# 60 Chandler Highway, Alphington / Urban Design Referral

<b>Council Reference</b>	PLN19/0606
<b>To</b>	Amy Hodgen – Senior Coordinator - Statutory Planning
<b>From</b>	Mark Sheppard – Principal

In July 2020, City of Yarra requested that **kinetica** undertake an urban design assessment of a proposed development at 60 Chandler Highway, Alphington (the Site) based upon the plans prepared by Elenberg Fraser and dated 10 July 2020.

Figure 1 – Built form transition from north to south along Chandler Highway with a reduction in height of one level to both Building A and Building B (Source: Elenberg Fraser with annotations)

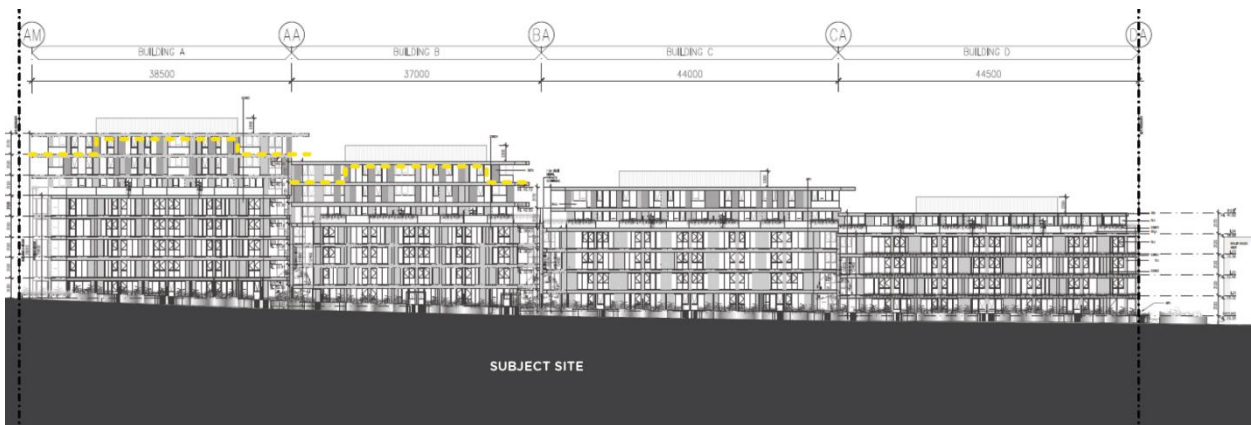
I consider that the proposed height of Building A is an inappropriate response to the DPO and Development Plan. I consider that two additional levels above the preferred maximum height would create an appropriate emphasis to mark the gateway. The proposed height of Building B would then not contribute to an appropriately graduated built form transition from north to south based on the preferred maximum 5 storey height to the south. However, the 6-storey height proposed for Building C will contribute appropriately to this transition.

In this context, a height of 7 storeys for Building A and 6 storeys for Building B would be a more appropriate response that reflects the intent for a transition, whilst also marking the gateway opportunity at the northern end of the Site, as illustrated below.

- **Delete Level 7 of Building A.**
- **Delete Level 6 of Building B.**
- **Redesign the grade of the Paper Trail link to improve its relationship with the east-west thoroughfare to its south. The redesign of the Paper Trail may necessitate a reconsideration of the height of the buildings in relation to it, and the relationship of the Ground Floor apartments to it.**

Figure 4 - North elevation (left) showing one level removed from Building A and South Elevation (right) showing one level removed from both Building A and Building B (Source: Elenberg Fraser with annotations)

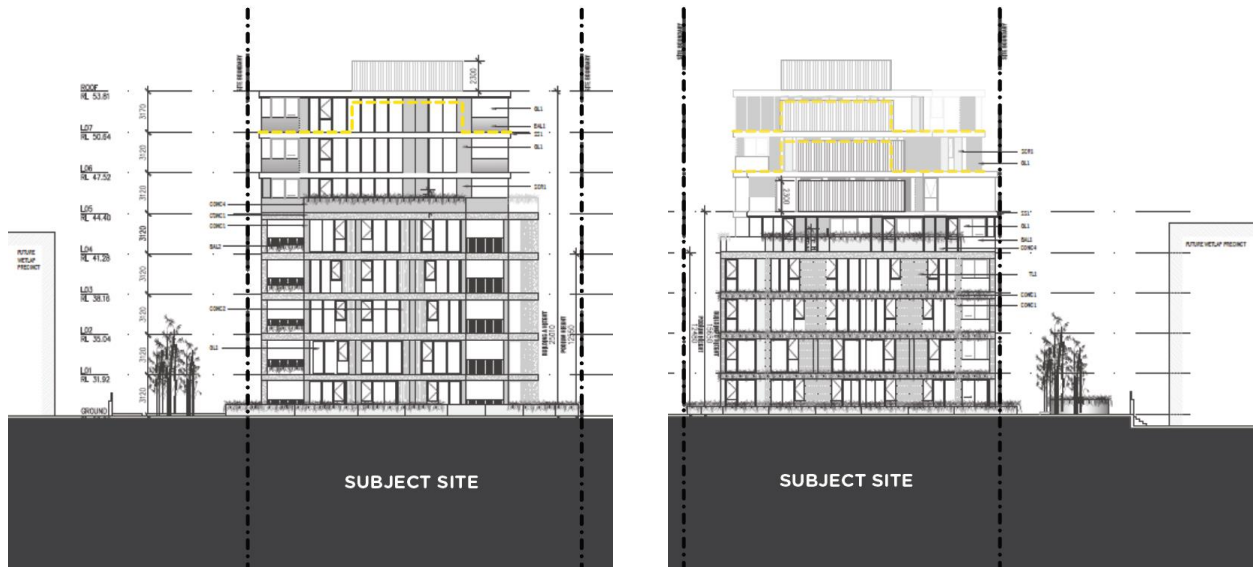
The recommended reduction in height of Building A and Building B will also result in a more appropriately graduated transition at the northern end of the Site from west to east, across to the 5 storey approved forms in Precinct 5, as illustrated below.
